Staff Report

Title: Project Hope Planned Unit

Development (ZMA-4-22)

Date: November 16, 2022

#### STAFF SITE PLAN ANALYSIS:

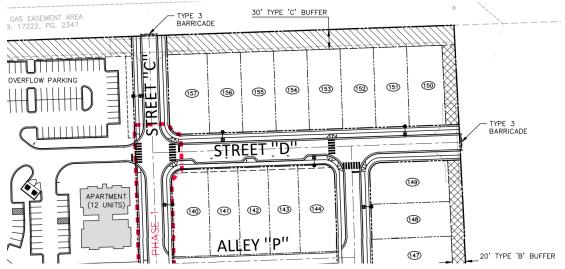
Staff has reviewed the plan for UDO consistency and found the site plan to generally be in compliance with the required provisions. The following items are being highlighted for Council review and further consideration.

### 3. **Required Distribution of Uses** (Section 11.1.B):

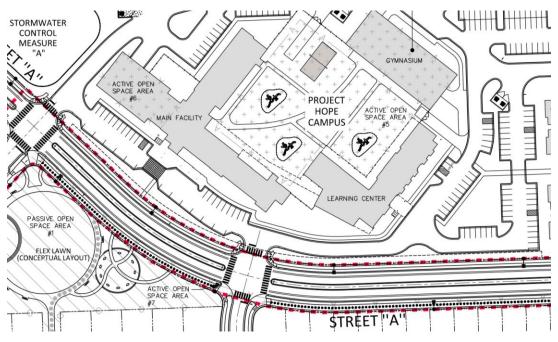
• **Requested**: The applicant proposes a neighborhood featuring a distribution of uses as shown below.

\*UDO distribution requirements for non-residential uses only apply to those projects incorporating non-residential uses. Within Project Hope, the commercial/mixed-use POD must contain a minimum of 2500 sq. ft of commercial space, but may otherwise contain other uses as permitted in the permitted use table included within this proposal.

\*\*For the purpose of this distribution of use table and in order to align with staff's recommendation for the site's water allocation use classification, the Raleigh Rescue Mission faciliity is categorized as Multifamily. However, the facility includes many office and support service functions and could easily be classified as mixed use instead.

### 8. **Motorized Vehicle Parking Calculations** (UDO Section 7.1.G):

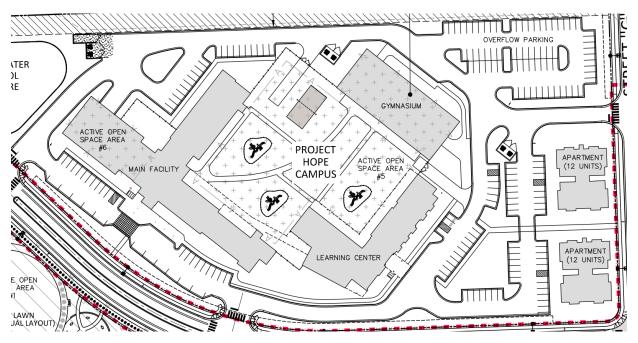
- **Required**: In accordance with UDO Section 7.1.G, this multi-family developments must provide 148 parking spaces.
- **Requested**: Based on the services provided by the Raleigh Rescue Mission, there is less demand for parking by residents. The applicant shall provide 118 off-street parking spaces, which should adequately serve residents and employees.
